Access Compliance Report

Public Rights-of-Way

Intersection ID: 47977	Main Street: AVALY_LN	Cross Street: SPRINGS_MILL_RD	Location: NE
ADA ID: EDDBFBD4F16E	Ramp Type: PerpDiag	Initial Pass/Fail: Fail	Overall Compliance: No
Severity Score: 8.75			
Codes/Mitigation Info/Possible Solution		Field Measurements/Component Compliance

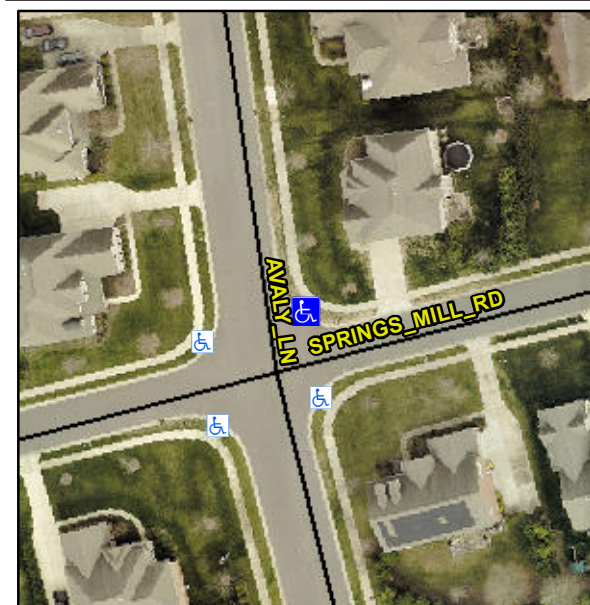
Not Found, R304.5.1

Compliance	Description	Data	Compliance	Description	Data
N/A	Ramp Length (in)	81.0	Yes	Ramp Slope (%)	5.7
No	Ramp Width (in)	39.0	Yes	Ramp XSlope (%)	0.2
N/A	Flare Type LT	N/A	N/A	Flare Type RT	N/A
N/A	Flare Slope LT (%)	N/A	N/A	Flare Slope RT (%)	N/A
N/A	Flare Traversable LT?	N/A	N/A	Flare Traversable RT?	N/A
N/A	Landing Length (in)	N/A	N/A	DWS Provided?	N/A
N/A	Landing Width (in)	N/A	N/A	DWS Contrast?	N/A
N/A	Landing Slope (%)	N/A	N/A	DWS Length (in)	N/A
N/A	Landing X Slope (%)	N/A	N/A	DWS Full Width?	N/A
N/A	Landing Curb? (Y/N)	N/A	N/A	DWS Offset (in)	N/A
N/A	Shared Landing?	N/A			
N/A	Gutter Ponding?	N/A	N/A	Gutter Slope (%)	N/A
N/A	Gutter Lip Ht (in)	N/A	N/A	Gutter X Slope (%)	N/A
N/A	Painted X Walk1?	No	N/A	Painted X Walk2?	No
	X Walk 1 Direction	To W		X Walk 2 Direction	To S
N/A	X Walk 1 Width (in)	N/A	N/A	X Walk 2 Width (in)	N/A
	X Walk 1 Slope (%)	0.5		X Walk 2 Slope (%)	0.1
	X Walk 1 X Slope (%)	2.1		X Walk 2 X Slope (%)	2.1

Remove & Replace Curb Ramp With Two New Directional Ramps or Equivalent.
